MP 09_0131 MOD 1
Z19/129369
MP-2009/131/A
13 June 2019

MODIFICATION TO CONCEPT PLAN (TALLAWARRA LANDS)

ATTACHMENT 1 - Comments in relation to the Proponent's Response to Submissions

Ridgeline Park- Northern Precinct

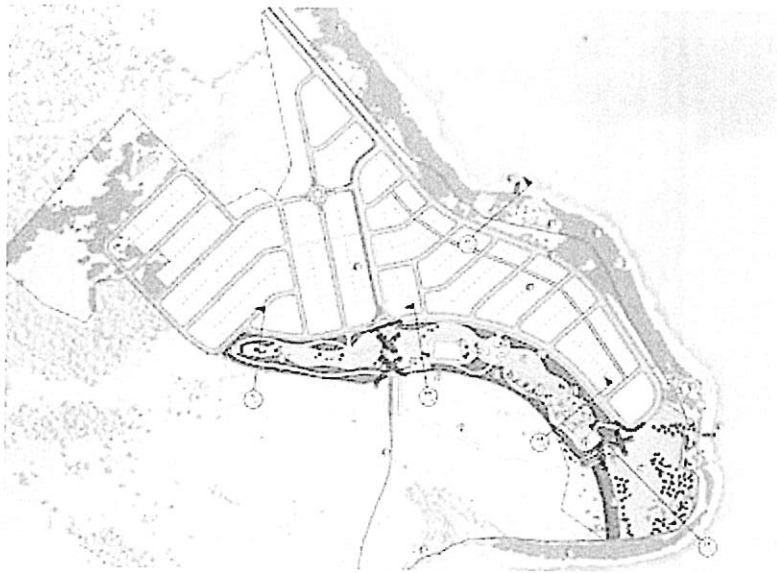
- Road widths should accommodate two directional flow and on-street parking along the entire frontage of the park.
- The road separating the foreshore and park/café is likely to attract anti-social activity. The road should terminate at intersection of foreshore road and park frontage road as shown below.
- The southern road off the roundabout should terminate at the roundabout as shown below
- The café will likely require parking and this should be shown on point park
- Community gardens are generally not supported by Council in this instance as their ongoing management is problematic
